Access Compliance Report

Public Rights-of-Way

Intersection ID: 52304	Main Street: IMPATIEN_DR	Cross Street: SNOWBELL_CT	Location: SW
ADA ID: C15CC8DC4DD9	Ramp Type: PerpDiag	Initial Pass/Fail: Fail	Overall Compliance: No
		Severity Score: 10

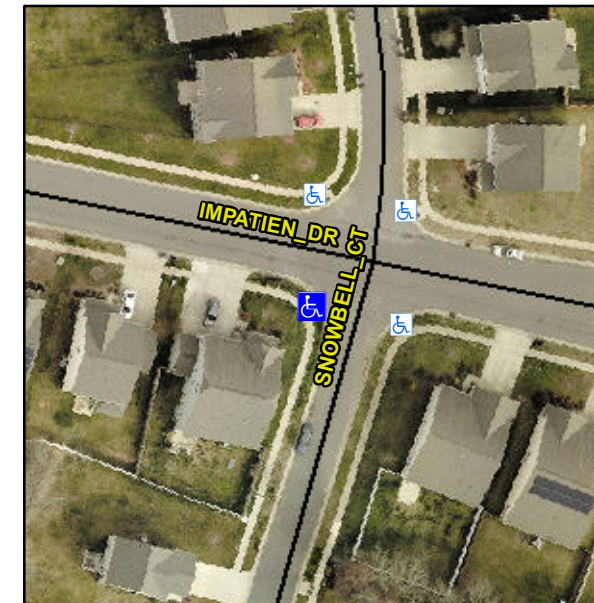
Not Found, R304.5.1, R304.5.3

Compliance	Description	Data	Compliance	Description	Data
N/A	Ramp Length (in)	70.5	Yes	Ramp Slope (%)	5.5
No	Ramp Width (in)	40.5	No	Ramp XSlope (%)	3.2
N/A	Flare Type LT	N/A	N/A	Flare Type RT	N/A
N/A	Flare Slope LT (%)	N/A	N/A	Flare Slope RT (%)	N/A
N/A	Flare Traversable LT?	N/A	N/A	Flare Traversable RT?	N/A
N/A	Landing Length (in)	N/A	N/A	DWS Provided?	N/A
N/A	Landing Width (in)	N/A	N/A	DWS Contrast?	N/A
N/A	Landing Slope (%)	N/A	N/A	DWS Length (in)	N/A
N/A	Landing X Slope (%)	N/A	N/A	DWS Full Width?	N/A
N/A	Landing Curb? (Y/N)	N/A	N/A	DWS Offset (in)	N/A
N/A	Shared Landing?	N/A			
N/A	Gutter Ponding?	N/A	N/A	Gutter Slope (%)	N/A
N/A	Gutter Lip Ht (in)	1.5	N/A	Gutter X Slope (%)	N/A
N/A	Painted X Walk1?	No	N/A	Painted X Walk2?	No
	X Walk 1 Direction	To E		X Walk 2 Direction	To N
N/A	X Walk 1 Width (in)	N/A	N/A	X Walk 2 Width (in)	N/A
	X Walk 1 Slope (%)	2.7		X Walk 2 Slope (%)	4.8
	X Walk 1 X Slope (%)	0.2		X Walk 2 X Slope (%)	3.9

Remove & Replace Curb Ramp With Two New Directional Ramps or Equivalent.
